PLAN AND ZONING COMMISSION MEETING

CITY OF DAVENPORT, IOWA

TUESDAY, NOVEMBER 16, 2021; 5:00 PM

Case P21-06: Request of C&L Plaza for a preliminary plat of Prairie Pointe 2nd Addition for a 45-lot subdivision on 19.26 acres, located north of East 58th Street and east of Eastern Avenue.
[Ward 8]

PROJECT
FINAL PLAT
WINDSOR HILLS 2nd ADDITION
DAVENPORT, IOWA 52807

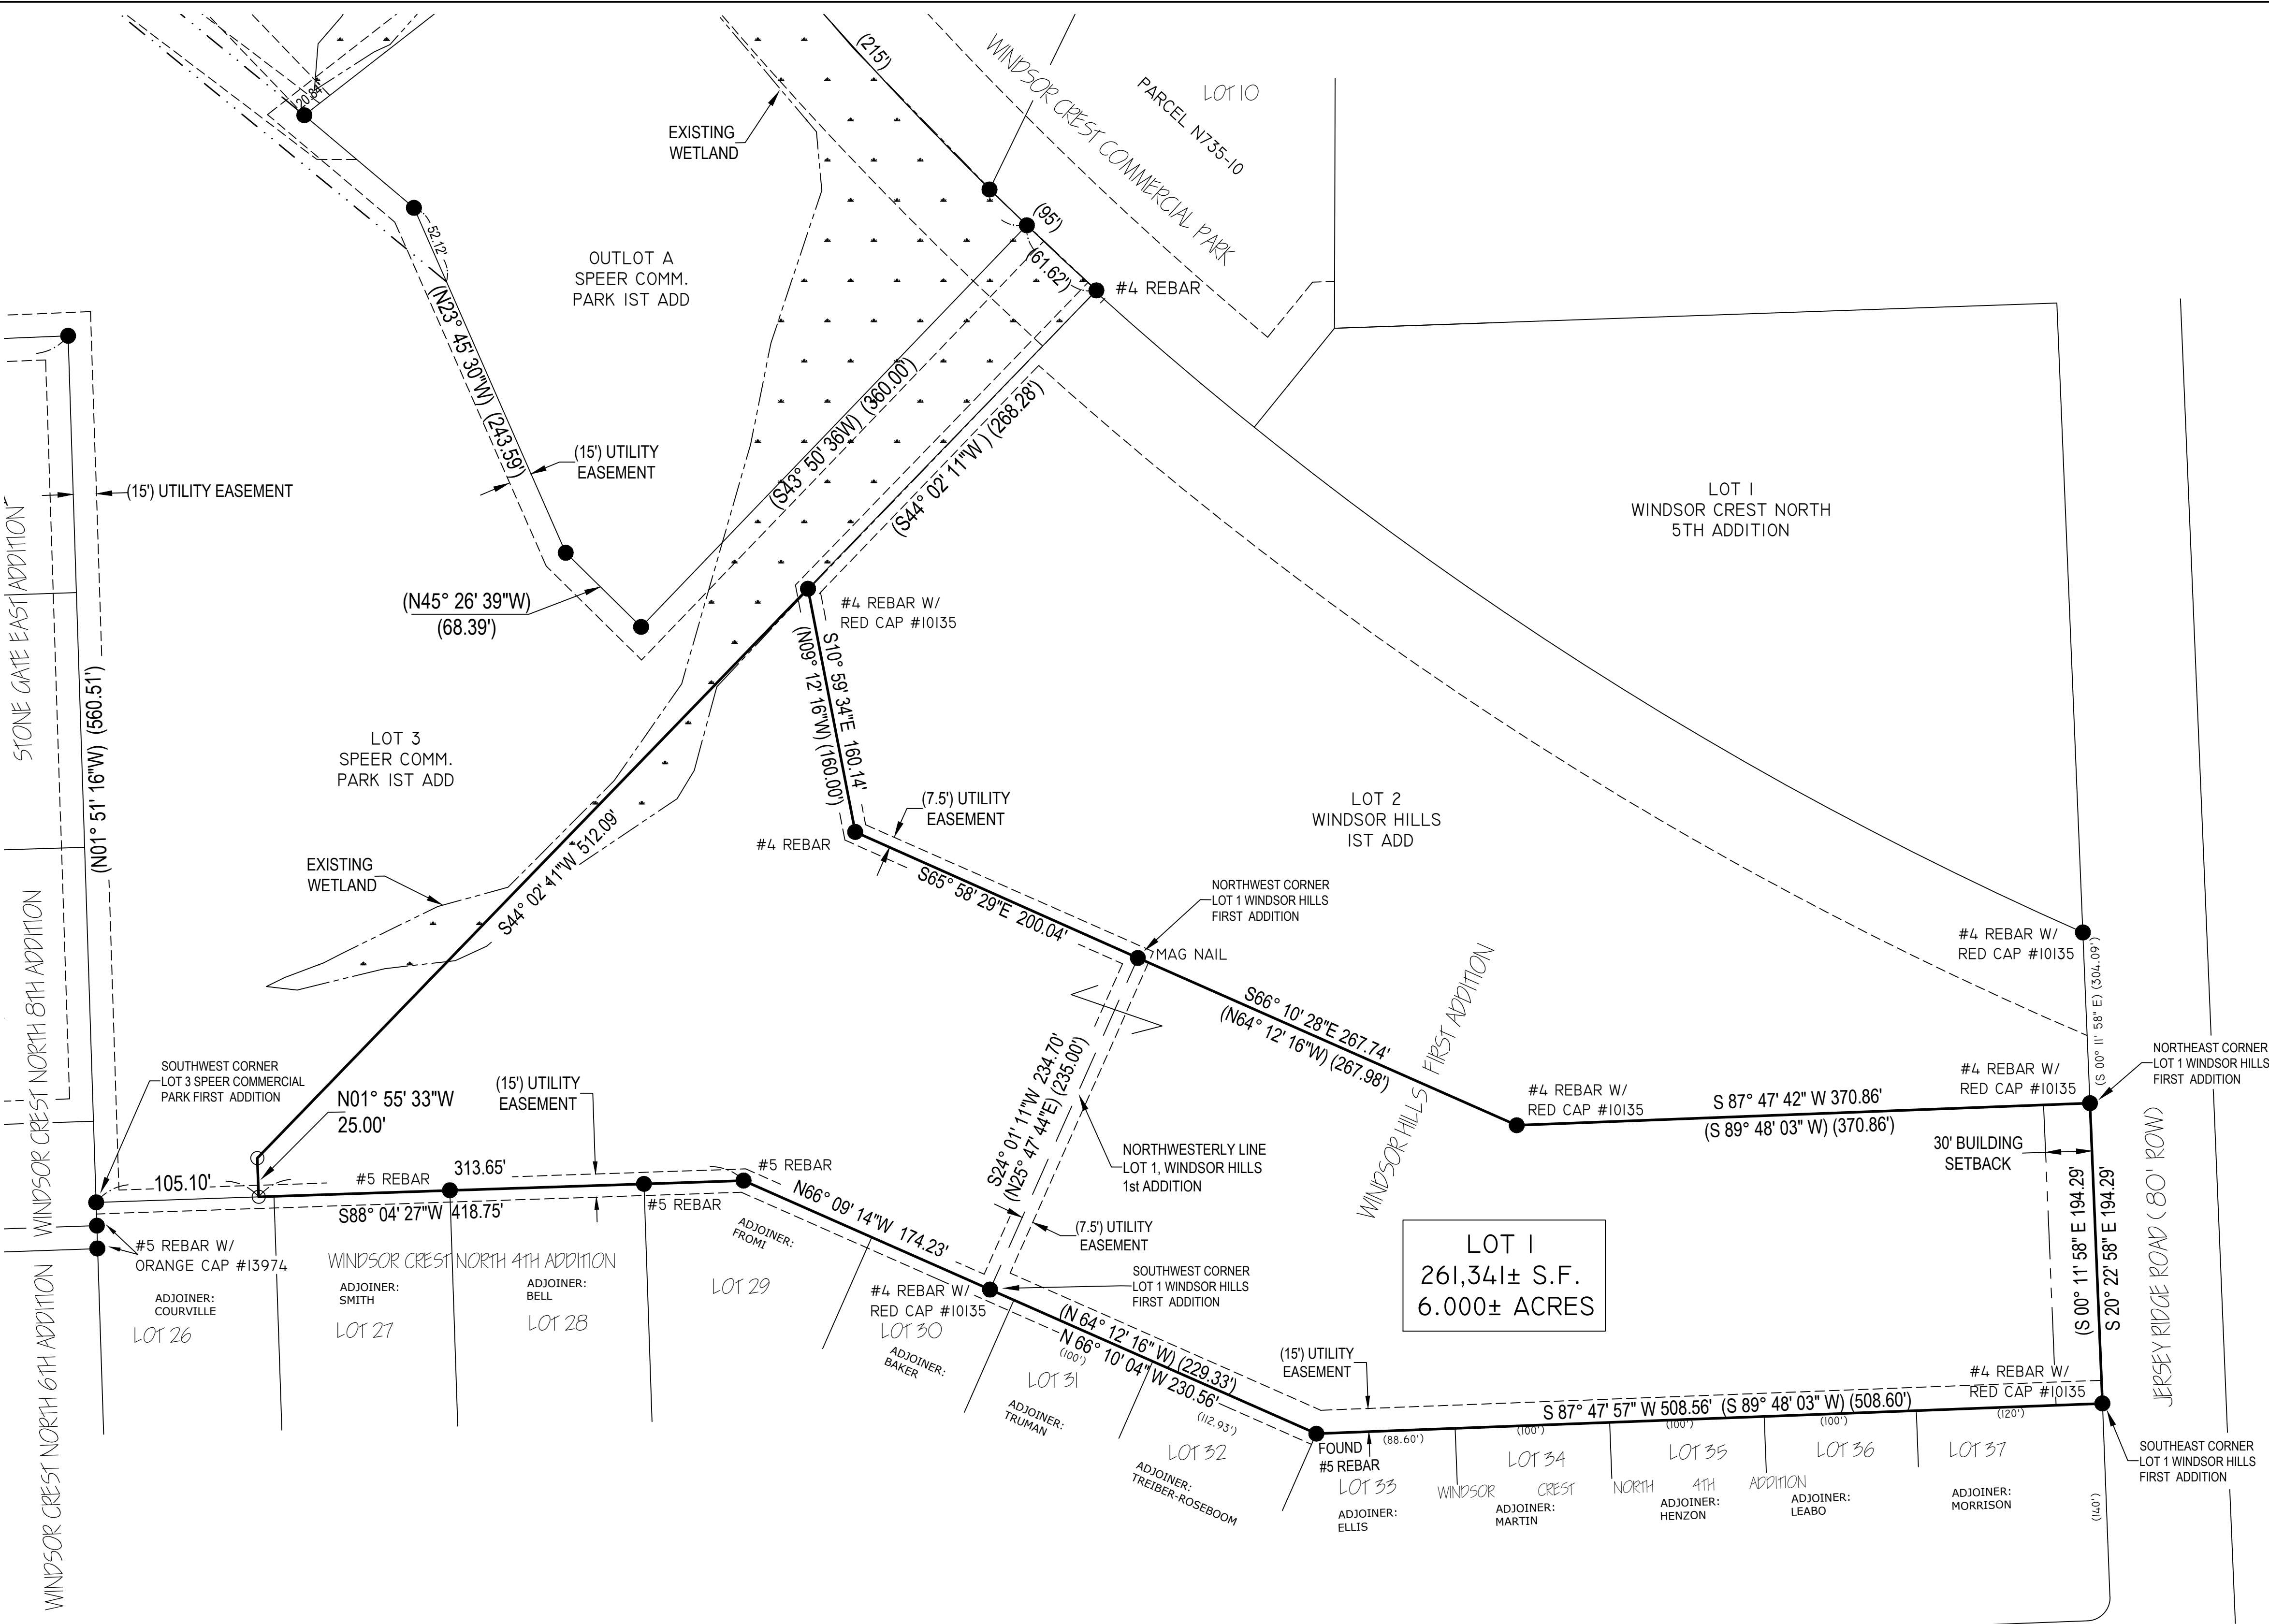
1. That the surveyor signs the plat.
2. That the utility providers sign the plat when their easement needs have been met.
3. Add an approval signature line for Metronet.

4. Add a note stating, "A landscape buffer yard shall be installed upon development in accordance with Section 17.11.080 of the Zoning Ordinance where lot lines are adjacent to single-family or two-family zoning districts."

5. Revise note #11 to state, "Owners of lots on which a wetland has been delineated shall not disturb flora, fauna and/or soil within designated boundaries."

6. All sanitary sewers on the lot shall be private. Remove references to public sanitary sewers.
7. Include a note regarding stormwater detention and water quality requirements that reads, "Stormwater detention and water quality treatment are required with this subdivision and will be subject to the applicable ordinances in place at the time of development."

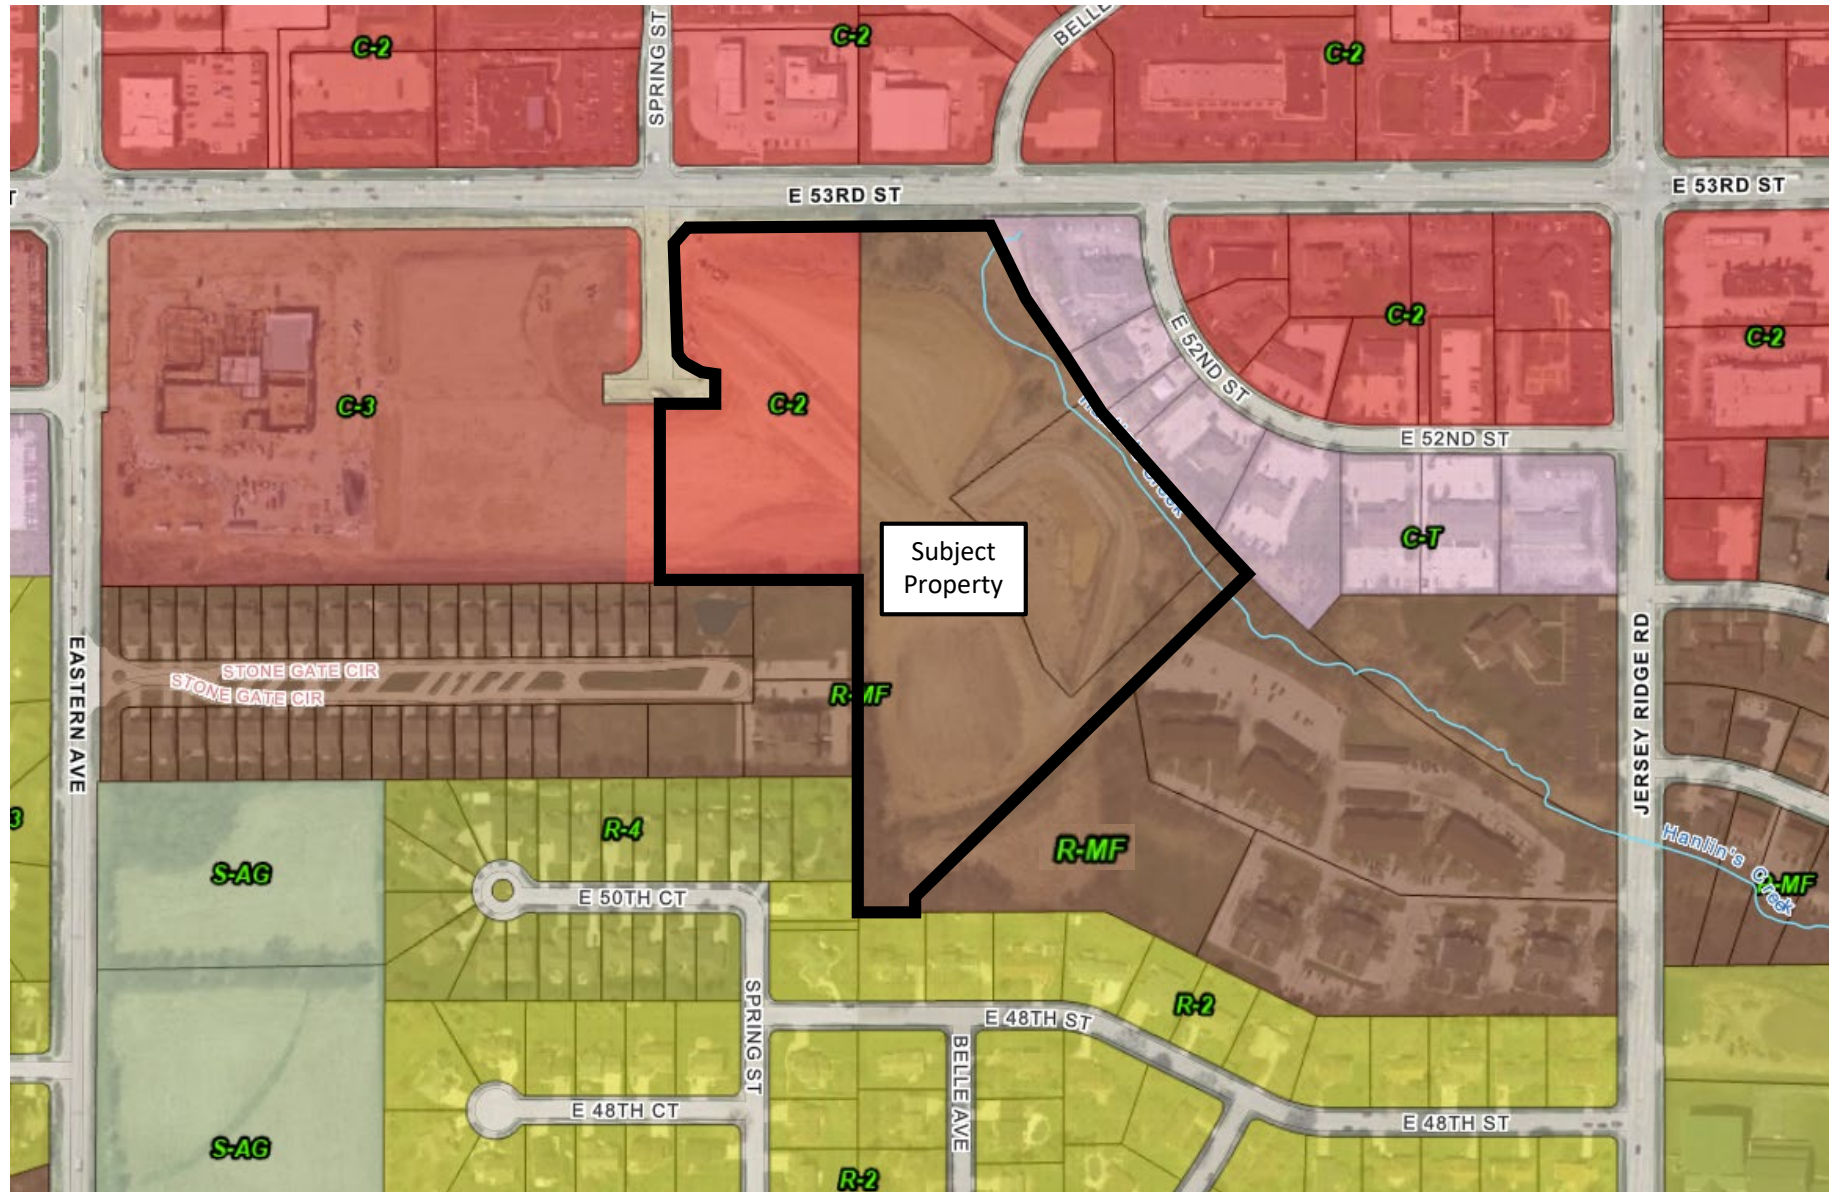
1. That the surveyor signs the plat.
2. That the utility providers sign the plat when their easement needs have been met.
3. Add an approval signature line for Metronet.
4. Delineate the R-MF Multi-Family Residential District and C-2 Corridor Commercial District boundaries on the plat. Add a note on the plat to reflect the split zoning of the site.
5. Add a note stating the C-2 portion of the property is subject to rezoning conditions in Ordinance 2017-520 and list the conditions as outlined in Section 17.17.010J of the Davenport Zoning Code.
6. Include a note regarding stormwater detention and water quality requirements that reads, "Stormwater detention and water quality treatment are required with this subdivision and will be subject to the applicable ordinances in place at the time of development."
